# ADDENDUM NO. 01

Bid #1508 Lot 8 Restriping
at
Santa Ana College

Project ID #3816

Project Name: **Lot 8 Restriping**
1530 W, 17th Street. Santa Ana, CA 92706

## 1 ENLARGED SITE - RECONSTRUCTION PLAN
Scale: 1" = 20'-0"

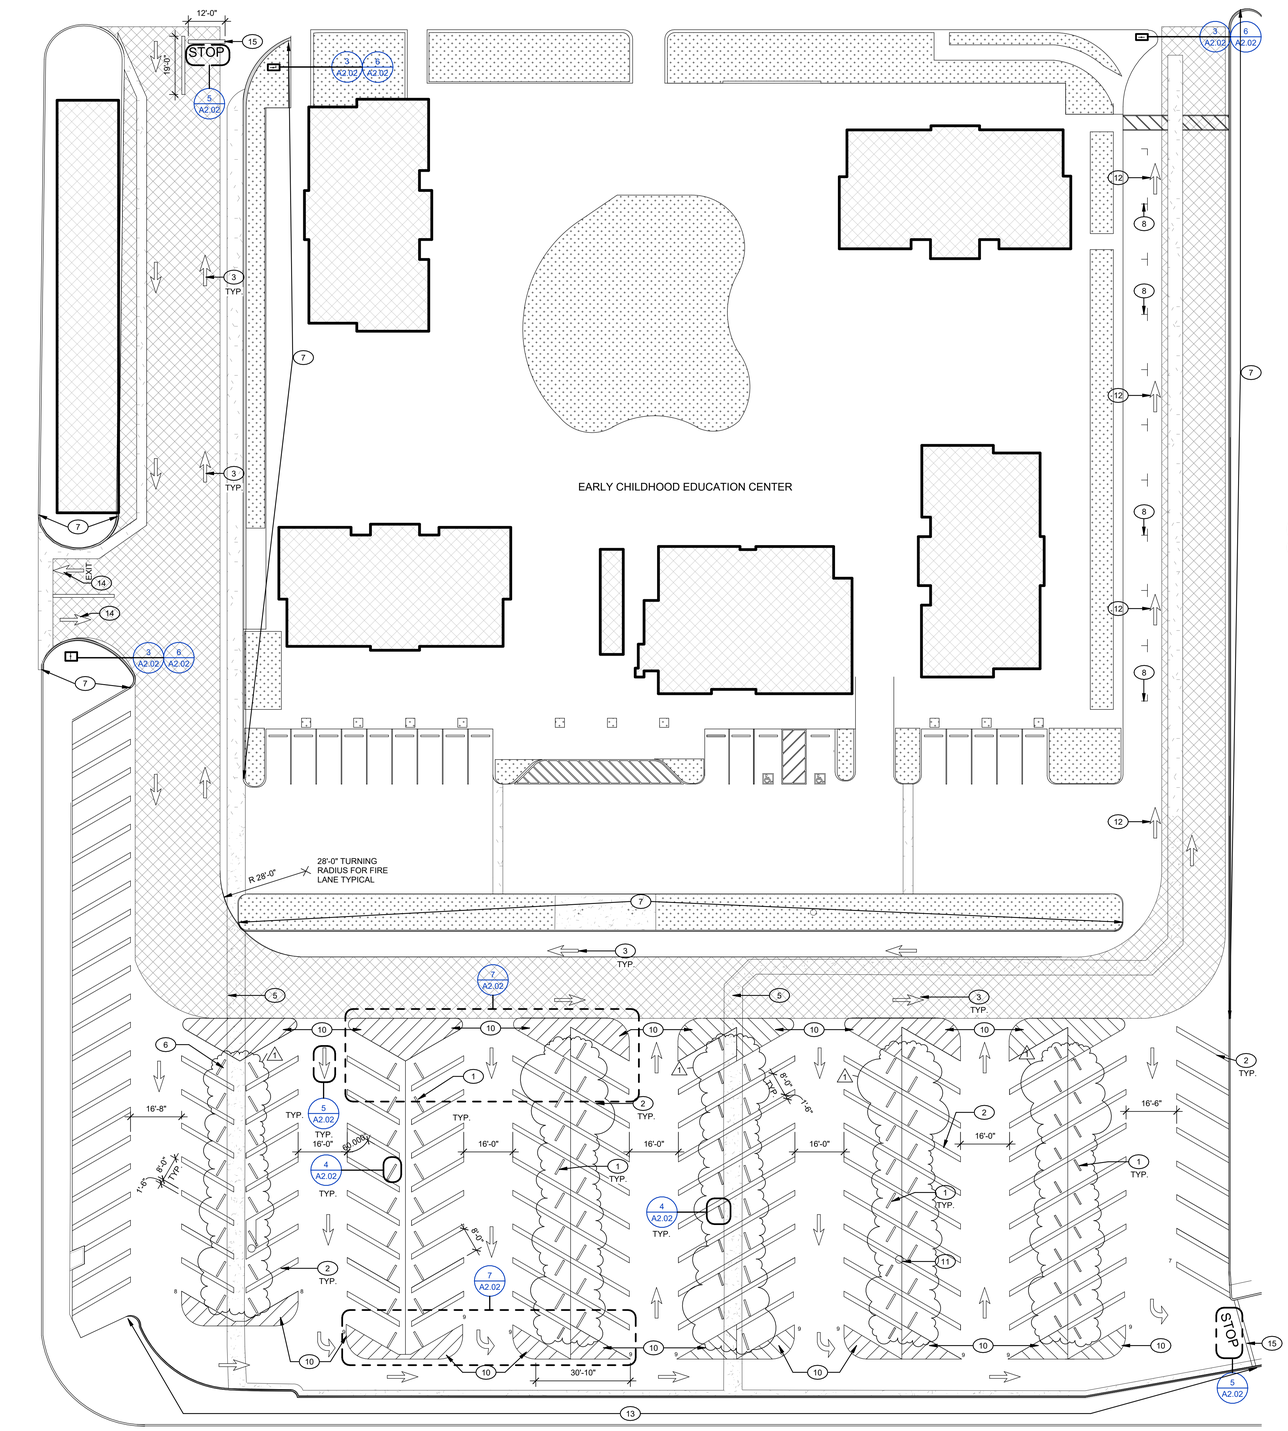
1. **A2.02**:
   A. Relocated wheel stops to ensure they are positioned entirely on asphalt and clear of swales.
   B. Shifted wheel stops off-center to properly align with vehicle wheel paths.
   C. The quantity of rubber wheel stops shown has increased. Reused existing 6'-0" rubber wheel stops. Once the existing wheel stops are exhausted, provide new 4'-0" wheel stops. At locations adjacent to swales, provide shorter wheel stops as required to avoid encroachment into the swale areas.
   D. Dividing striping at four locations to separate the east and west parking stall areas added. Omitted dividing striping at the two locations where a swale separates the parking areas.
   E. Revised enlarged site plan coded notes to reflect drawing changes.

1. REINSTALL EXISTING WHEEL STOPS. CONTRACTOR TO PROVIDE ADDITIONAL WHEEL STOPS WHERE NEEDED.
2. 4" WIDE PAINTED PARKING LOT STRIPING AT PARKING SPACES AND CONTROL DESIGNATION, SEE DETAIL 5.
3. TRAFFIC CONTROL PAVEMENT MARKING, SEE DETAIL 5.
4. PATCH AND REPAIR ASPHALT PAVING WHERE WHEEL STOPS ARE REMOVED TYPICAL.
5. EXISTING CONCRETE GUTTER TO REMAIN.
6. NOT USED.
7. RED CURB STRIPING AT FIRE LANE TYPICAL, SEE DETAIL 2.
8. EXISTING PARKING TO REMAIN.
9. NOT USED.
10. ENDCAP PAINTING. 4" WIDE PAINTING STRIPE, 3'-0" SPACING, ANGLED 45 DEGREES.
11. EXISTING LIGHT POLE.
12. REPAINT EXISTING ARROWS AT THEIR CURRENT LOCATION (OLD ASPHALT).
13. REPAINT RED CURB, NO PARKING
14. EXISTING STRIPING TO REMAIN.
15. 12" WIDE WHITE PAINTED STOP OR DIVIDER LINE.
